Access Compliance Report

Public Rights-of-Way

Intersection ID: 8212	Main Street: ALLENBROOK_DR	Cross Street: TANGLEBRIAR_DR	Location:	N
ADA ID: 036EB274B5DC	Ramp Type: Perp	Initial Pass/Fail: Fail	Overall Compliance: No	Severity Score: 25
Codes/Mitigation Info/Possible Solution		Field Measurements/Component Compliance

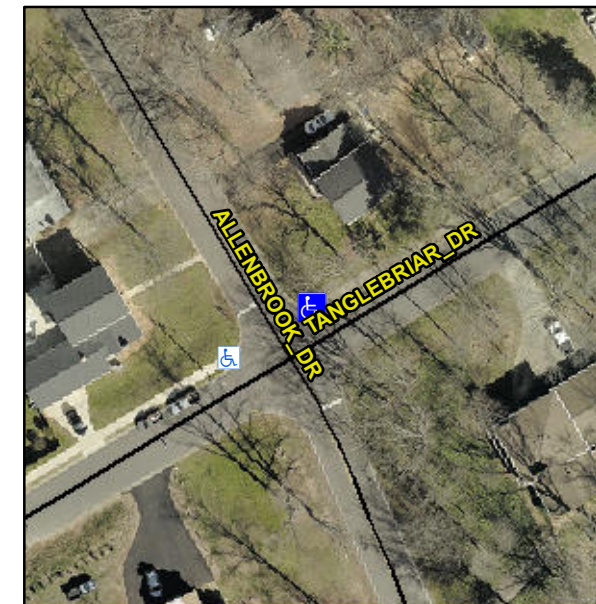
Not Found, R304.5.3

Compliance	Description	Data	Compliance	Description	Data
N/A	Ramp Length (in)	37.5	Yes	Ramp Slope (%)	7.7
Yes	Ramp Width (in)	48.0	No	Ramp XSlope (%)	9.7
N/A	Flare Type LT	N/A	N/A	Flare Type RT	N/A
N/A	Flare Slope LT (%)	N/A	N/A	Flare Slope RT (%)	N/A
N/A	Flare Traversable LT?	N/A	N/A	Flare Traversable RT?	N/A
N/A	Landing Length (in)	N/A	N/A	DWS Provided?	N/A
N/A	Landing Width (in)	N/A	N/A	DWS Contrast?	N/A
N/A	Landing Slope (%)	N/A	N/A	DWS Length (in)	N/A
N/A	Landing X Slope (%)	N/A	N/A	DWS Full Width?	N/A
N/A	Landing Curb? (Y/N)	N/A	N/A	DWS Offset (in)	N/A
N/A	Shared Landing?	N/A			
N/A	Gutter Ponding?	N/A	N/A	Gutter Slope (%)	N/A
N/A	Gutter Lip Ht (in)	N/A	N/A	Gutter X Slope (%)	N/A
N/A	Painted X Walk1?	No	N/A	Painted X Walk2?	N/A
	X Walk 1 Direction	To SW		X Walk 2 Direction	N/A
N/A	X Walk 1 Width (in)	N/A	N/A	X Walk 2 Width (in)	N/A
	X Walk 1 Slope (%)	3.2		X Walk 2 Slope (%)	N/A
	X Walk 1 X Slope (%)	9.2		X Walk 2 X Slope (%)	N/A

Remove & Replace Entire Ramp.
